From: [Yu, Olivia, EMNRD](#)
To: ["Robbie Runnels"](#); John.Wierzowiecki@blackmtn.com; ["Mann, Ryan"](#)
Subject: RE: Black Mountain - State K #2 - 1RP-4675
Date: Friday, September 21, 2018 8:51:00 AM

Depth to Groundwater

BLACK MOUNTAIN RESOURCES STATE K #2

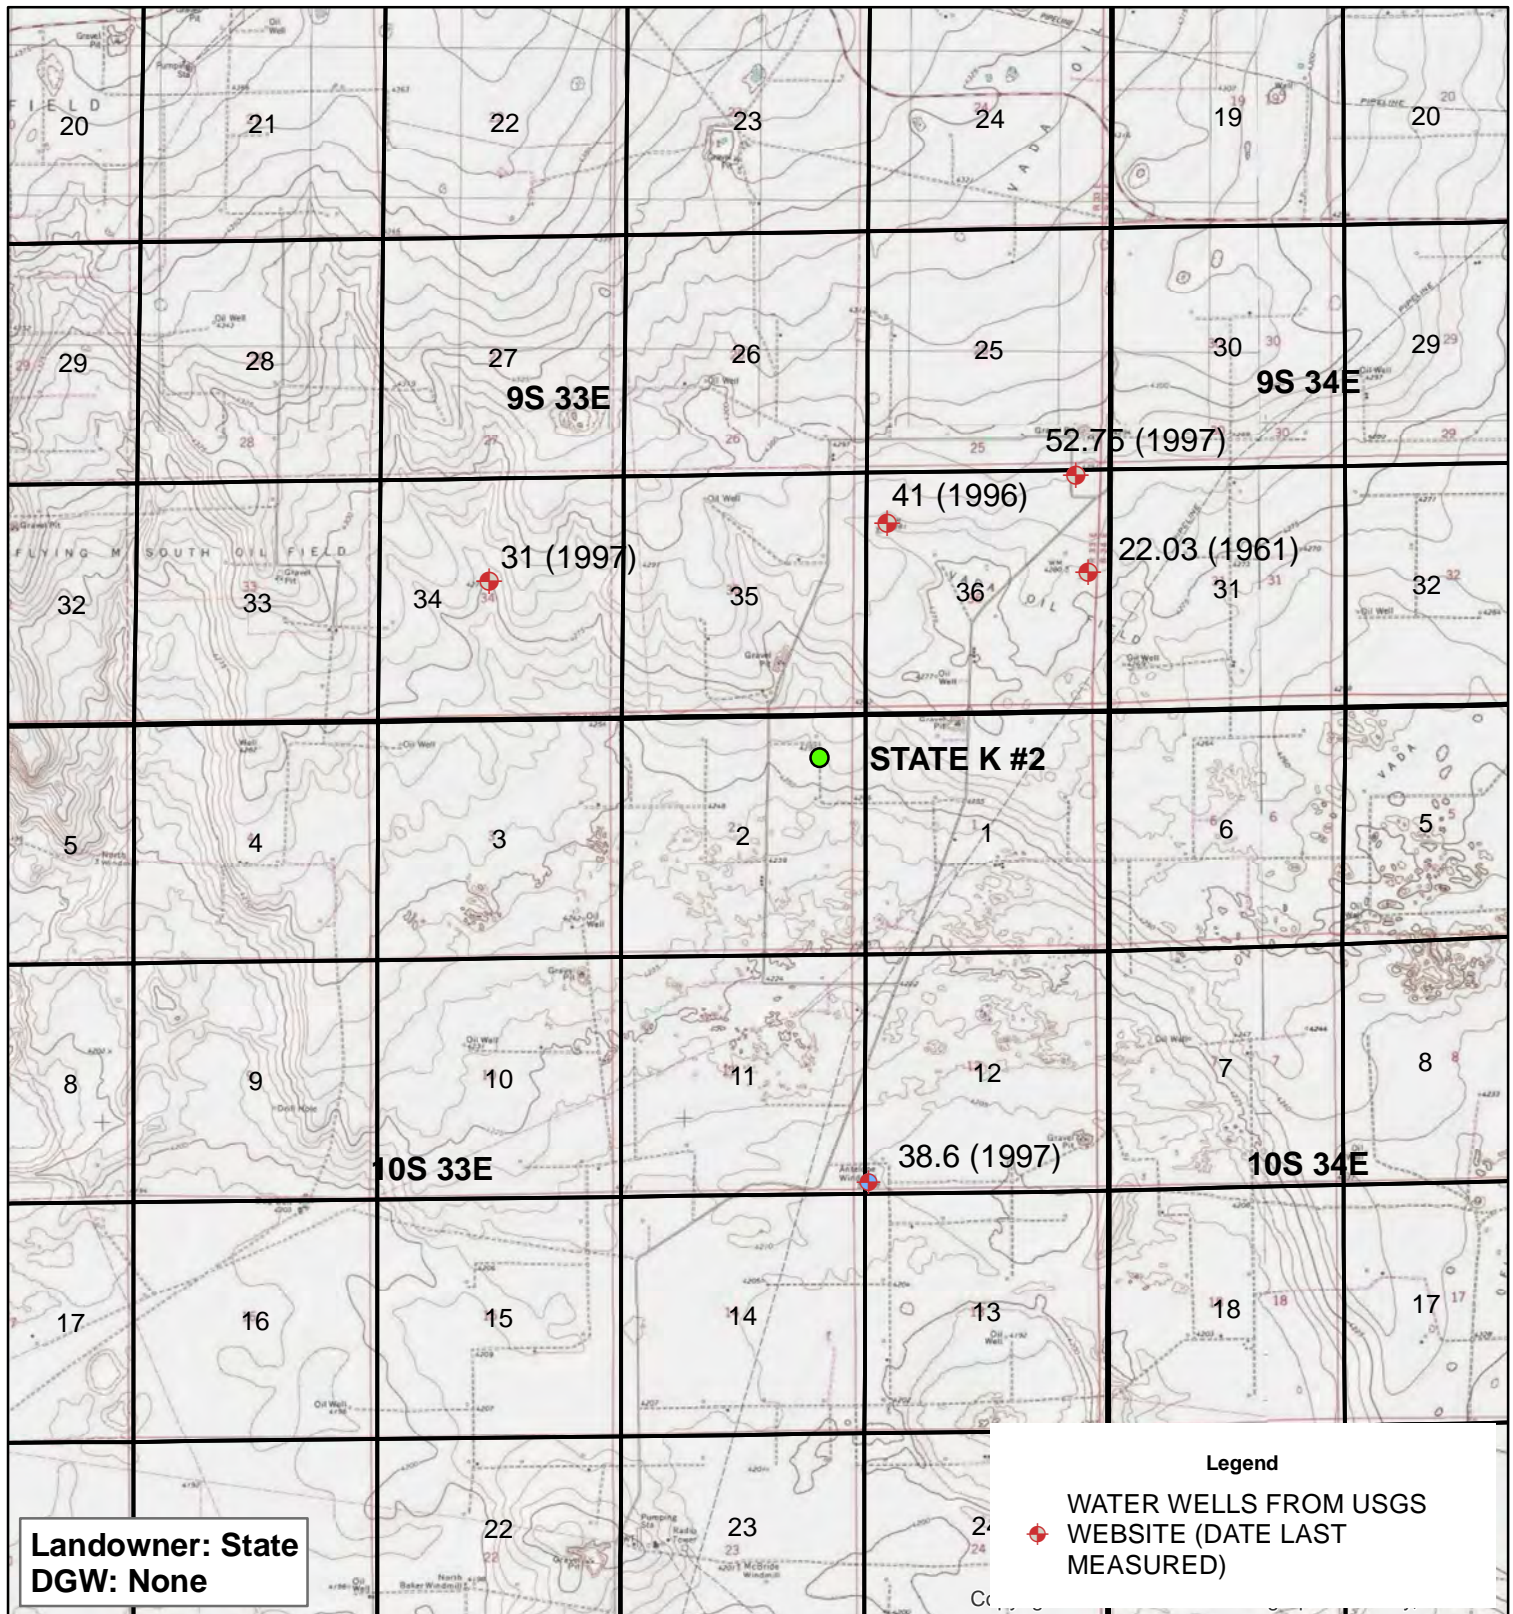
I have attached an "updated" DGW map. Only one of the wells is in approximation of 1 mile from the remediation site and the last time it was measured was 22 years ago. I am available to speak to you any time at your convenience.

Please call me to discuss this closure. But before you do, please double check that your GIS data for USGS wells has been updated.

Thanks for the confirmation. My ArcGIS show similarly. I believe these USGS wells are relevant as there were no NMOSE wells in the area. Unless the confirmation sidewall and bottom samples indicate otherwise, there will be no need for a phone call. I will be assessing the closure report according to RRALs of depth to groundwater of 50-99 ft. bgs.
